# STAFF REPORT

#### CASE NUMBER

PS-2-2020

#### SUMMARY OF REQUEST

# CROWN SQUARE

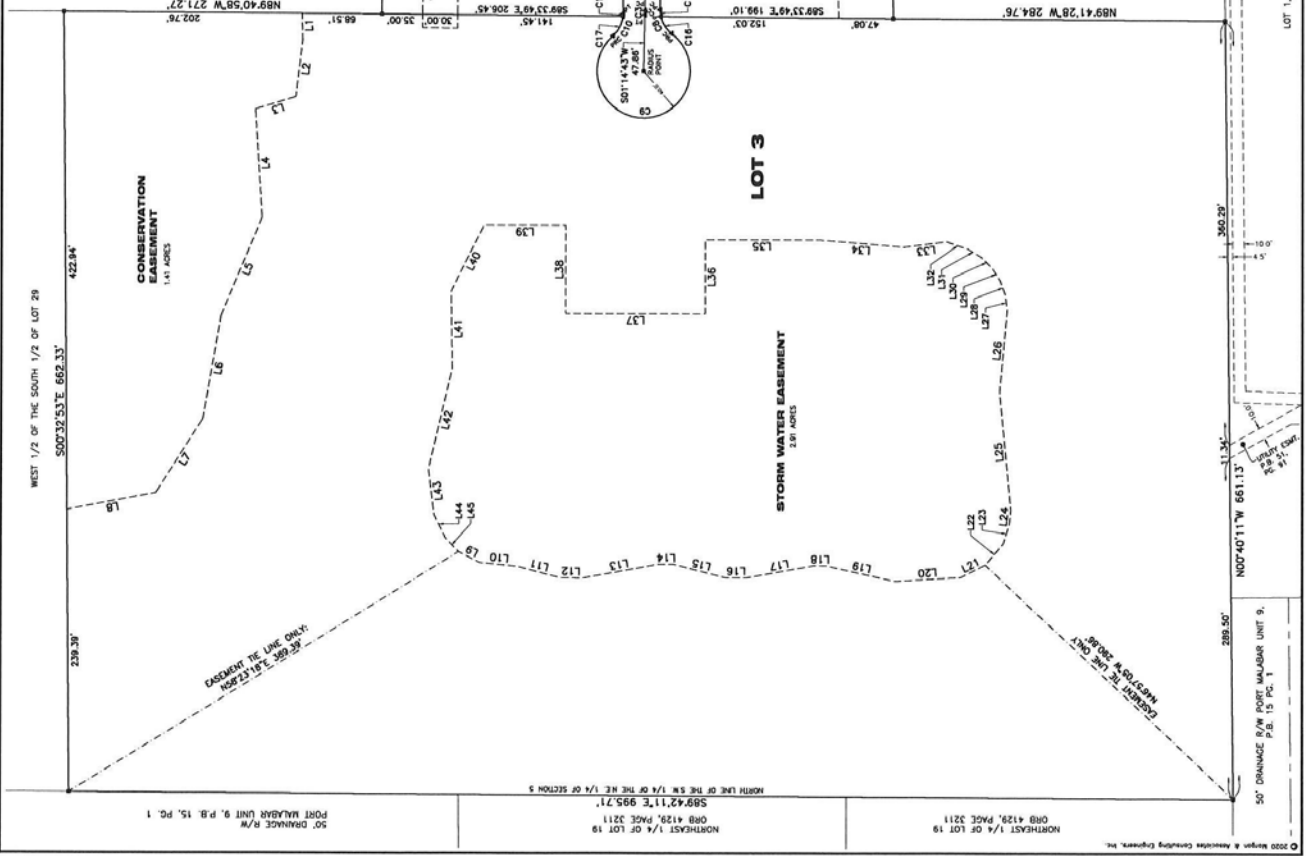
**Road Design:** The overall property, consisting of 21 acres, only has 400' of frontage on Malabar Road. In order to create the five (5) lots for conveyance, a new road must be established providing each lot with the minimum code-required frontage upon a legally created road right-of-way (ROW). The road itself must have a minimum 50' of ROW width, a maximum dead-end length of 1,000' and a minimum cul-de-sac ROW radius of 50'.

Crown Square Way is proposed within the middle of the project frontage on Malabar Road and will align with an existing median opening. A traffic signal is currently in the design stages. This newly created ROW extends approximately 720' from Malabar Road and terminates into a cul-de-sac for access to a future apartment complex. The road does not connect to any other

roadways, existing or proposed. The minimum width of this new road ROW is only 32' and the cul-de-sac radius is only 40'. Thus, the applicant has provided a Summary Request for "Waivers" from these two (2) requirements, per Section 184.14. This section allows the City Council to defer or waive, at the time of final approval, the provisions of any or all such design improvements, that in the Council's judgment are deemed not requisite in the interests of public health and safety, or inappropriate because of inadequacy or lack of connecting facilities (i.e. utilities).

An engineered site plan (Site Plan # 1370) is currently under administrative review. These plans propose development upon each of the five (5) lots. The reduced ROW width is the result of the overall width of the subject properties and the intended development of the commercial lots. A grocery store, retail establishment and two (2) restaurants are proposed. Siting of the buildings, required parking areas and drive aisles, and landscaping have necessitated the narrowing of the ROW width. Reduction of the cul-de-sac radius is to accommodate parking spaces for the clubhouse of the apartment complex that is located at the terminus of Crown Square Way. It shall be noted that ample pavement has been designed to accommodate the maneuverability of delivery and service vehicles.

Upon review of the submitted materials, the Preliminary Subdivision request is in substantial conformance with the applicable requirements of the Subdivision Code. Therefore, Staff recommends approval of Case PS-2-2020, subject to the following items being submitted with the Final Subdivision application:

- A. Declaration of Covenants, Conditions, and Restrictions;
- B. School Concurrency Determination Letter;
- C. An Environmental Study that includes a Endangered Species Assessment;
- D. Approved Traffic Signal plans; and
- E. The name of the proposed roadway "Crown Square Way" was denied by the office of Brevard County Address Assignment. An approved name shall be provided upon the Final Plat.
